FORESTSIDE TOWNHOUSES

SITE INSTRUCTION # 9

Date: August 23 , 2022

JAP Project No: 19066

2ND FLOOR FRAMING PLAN SCALE 1:100

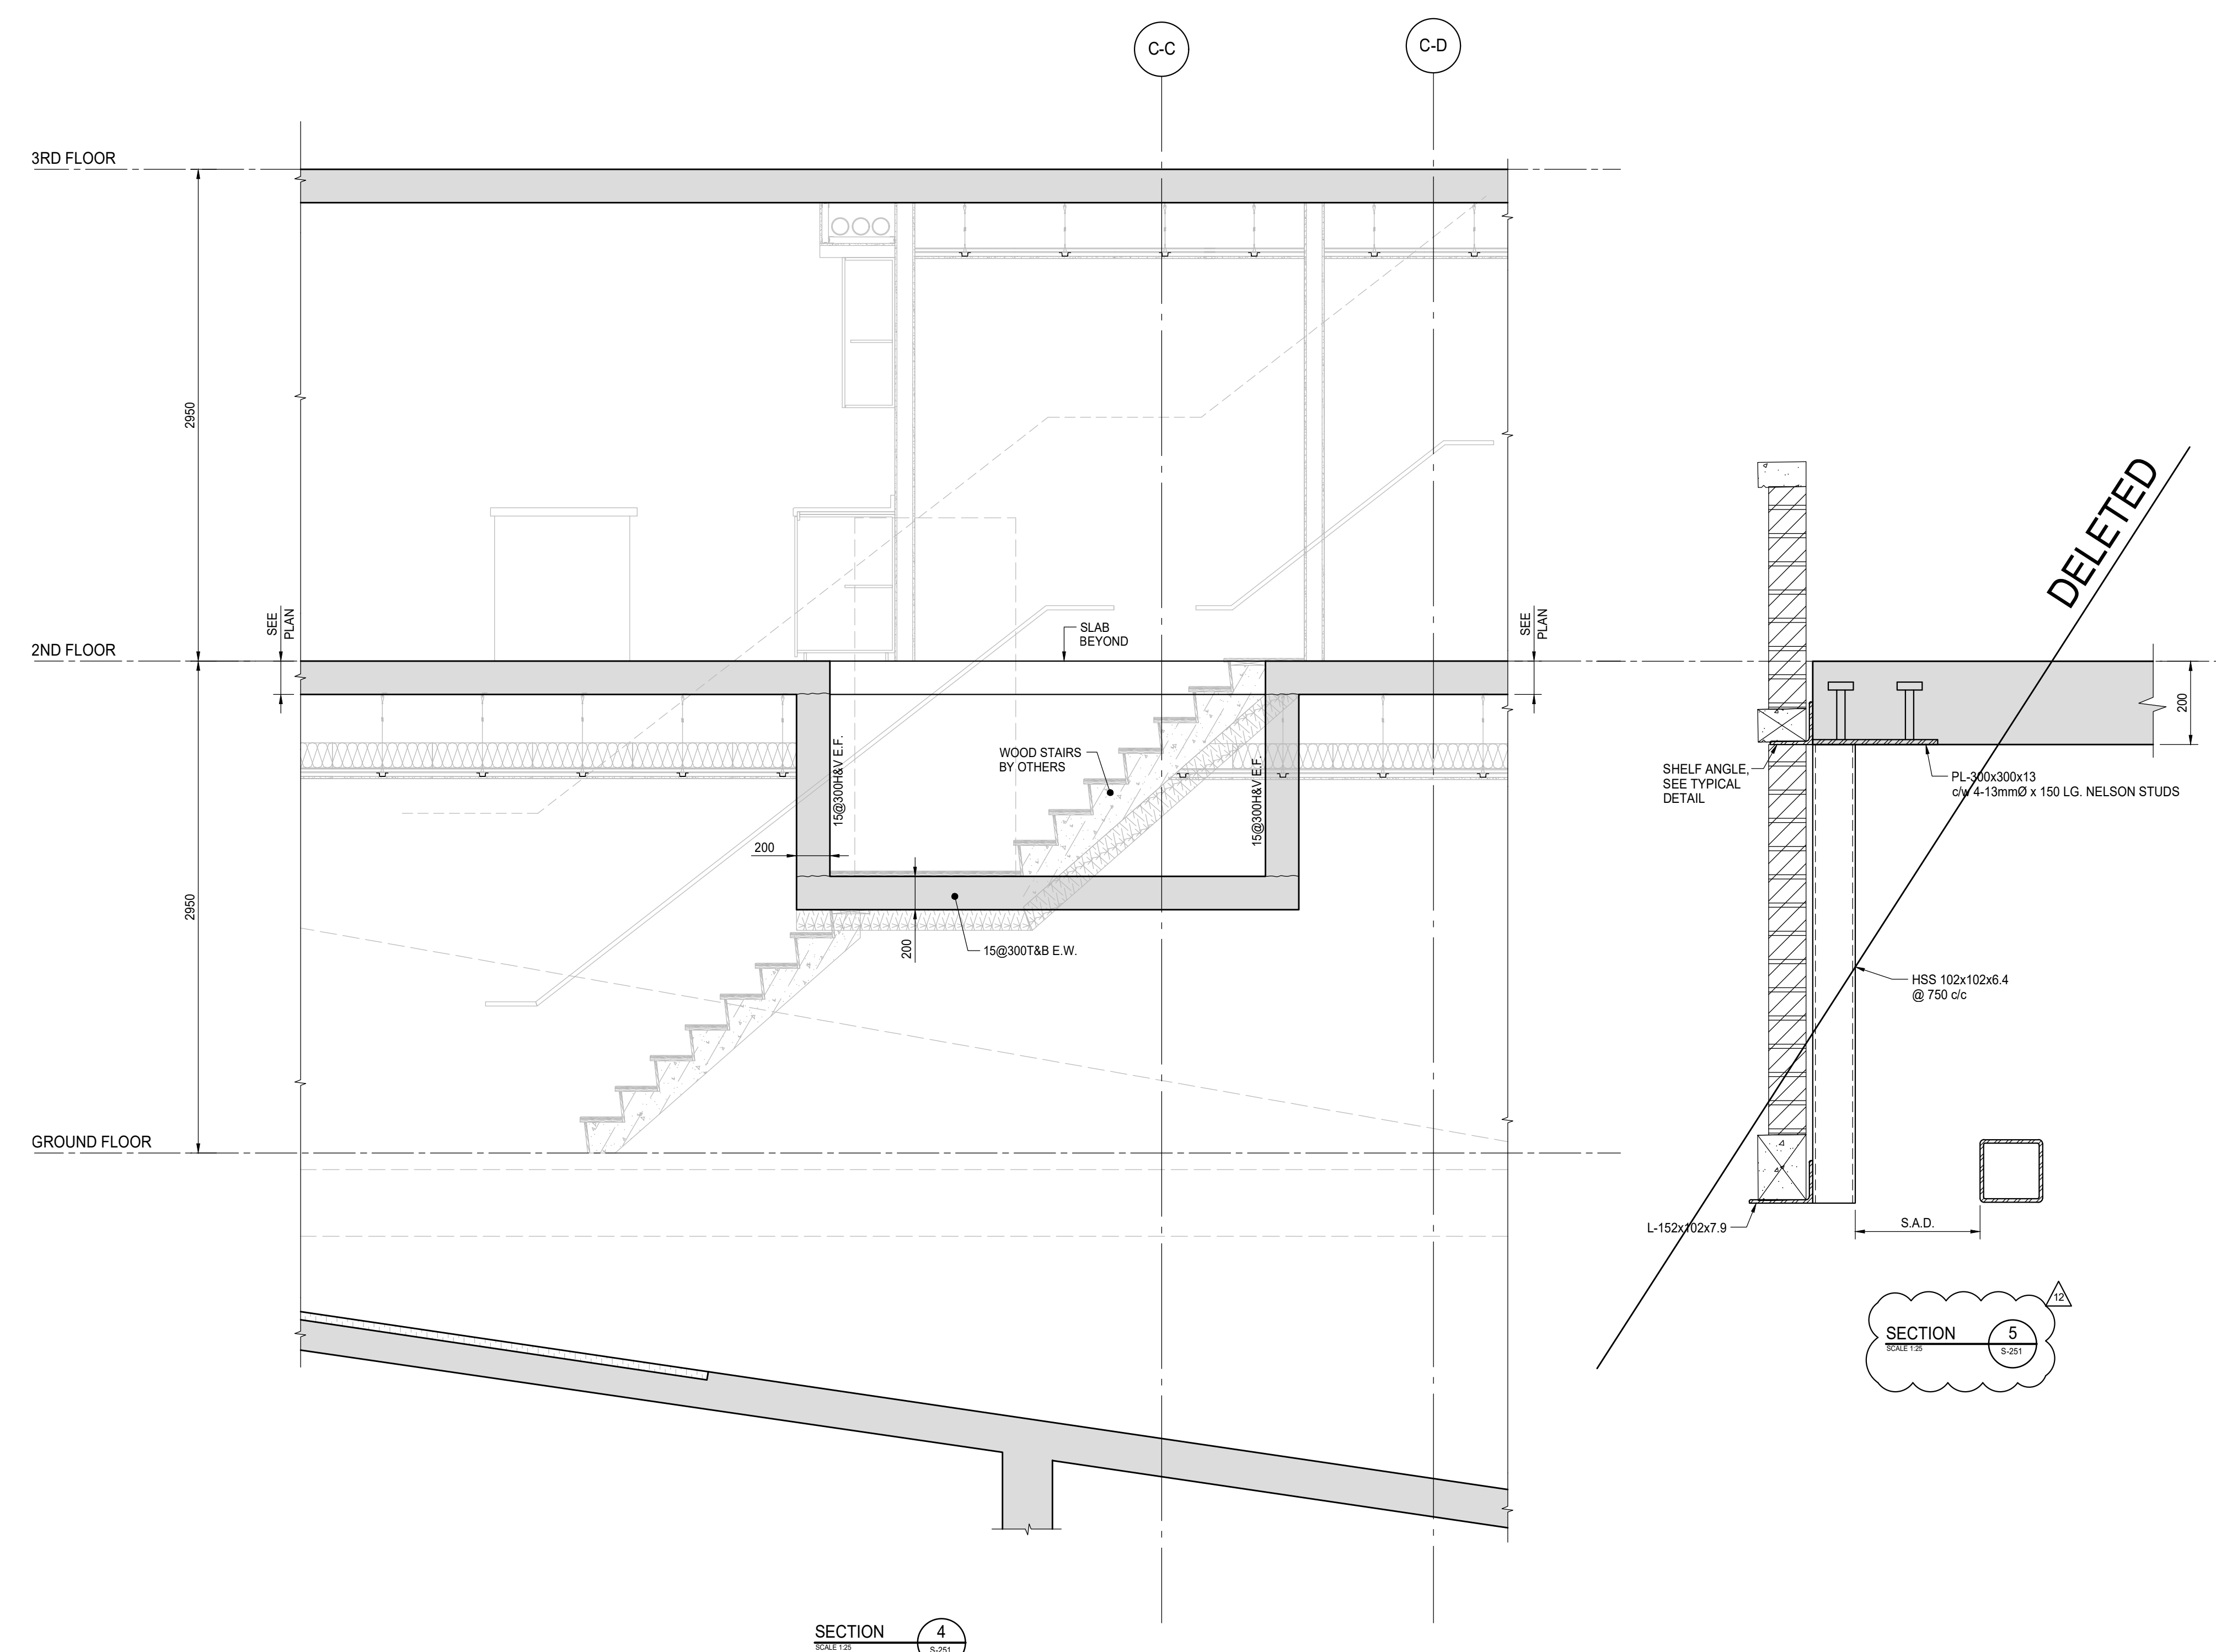
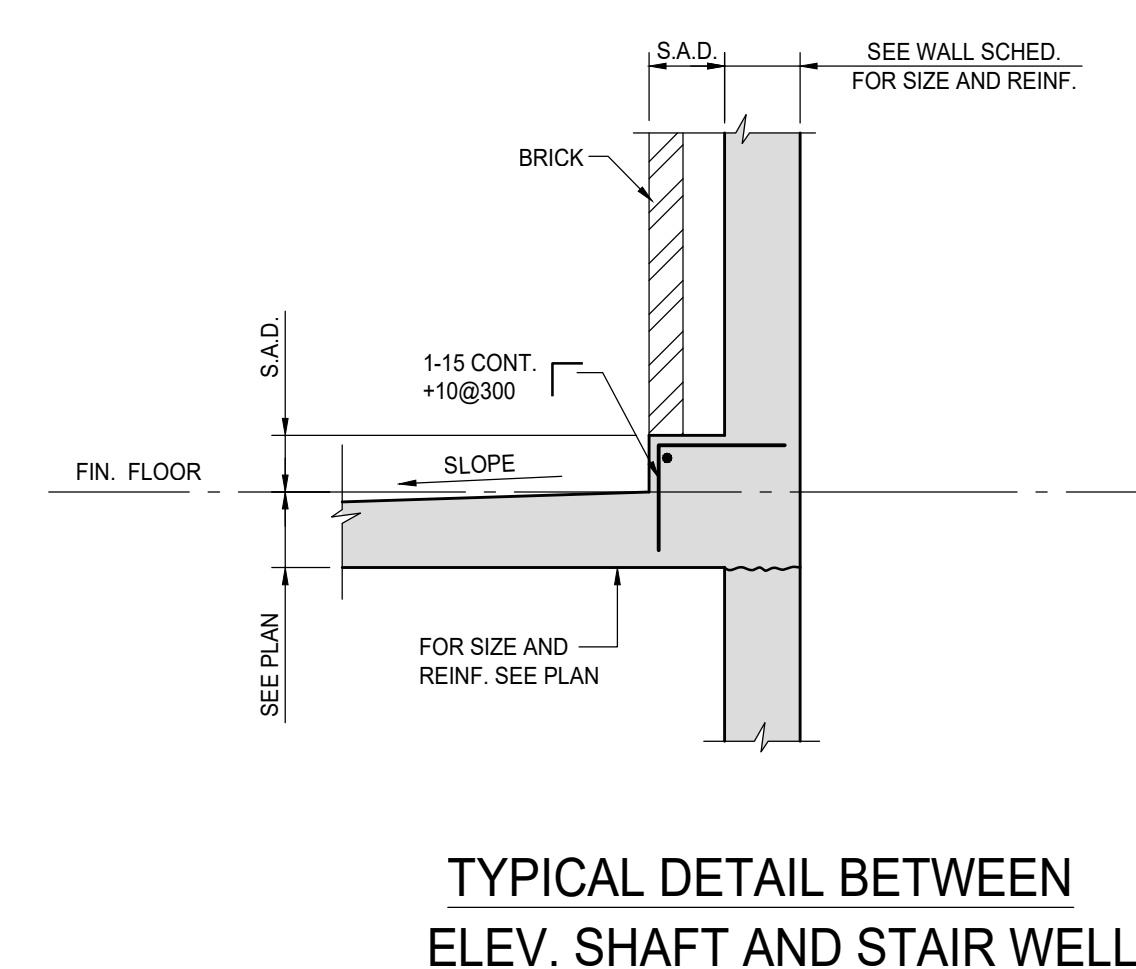
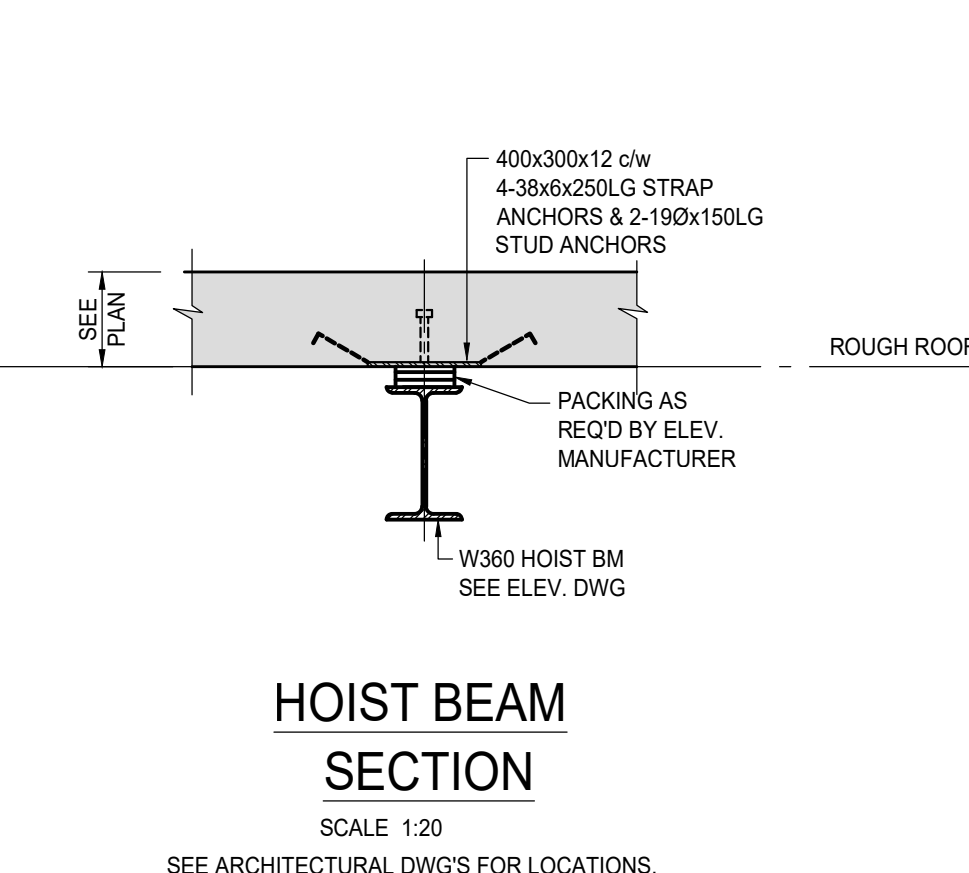
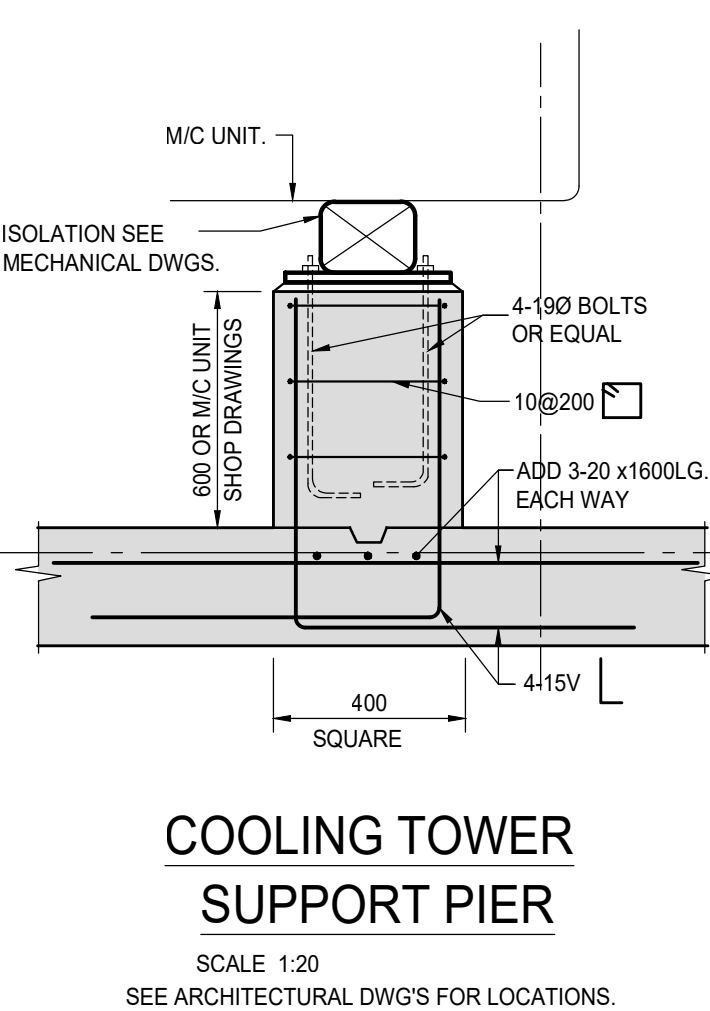
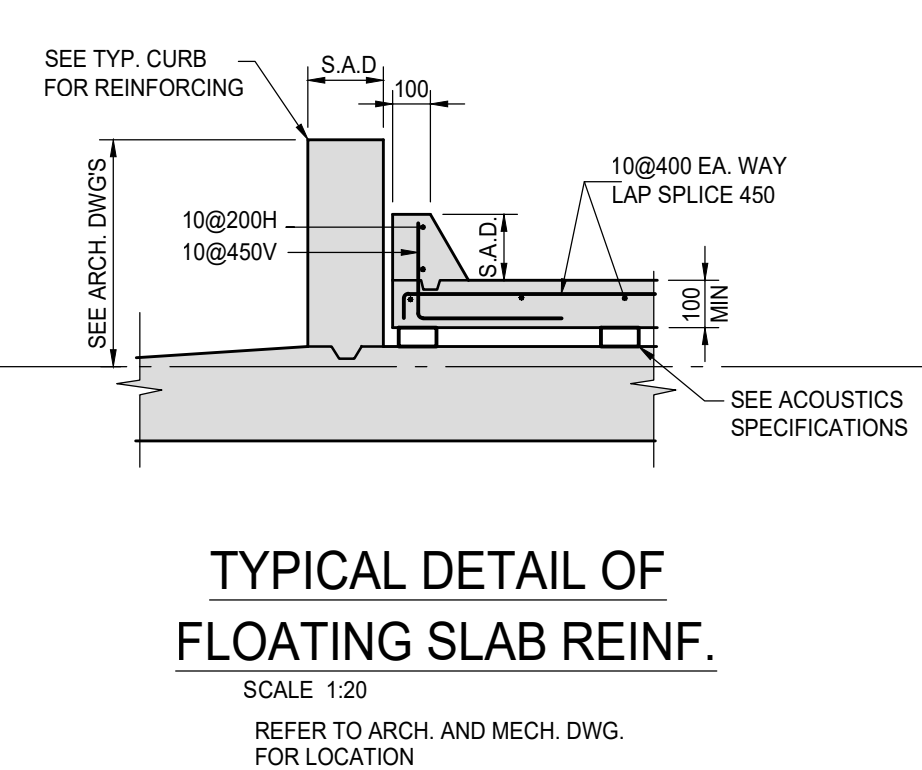
- 1.1 **Refer to Drawing S-102B "GROUND FLOOR FRAMING PLAN"**
 - a) Updated overhead door and brick support at garage entrance
- 1.2 **Refer to Drawing S-103B "2ND FLOOR FRAMING PLAN"**
 - b) Updated overhead door and brick support at garage entrance
 - c) Deleted section 5/S-251
- 1.3 **Refer to Drawing S-251 "SECTIONS"**
 - d) Deleted section as bubbled
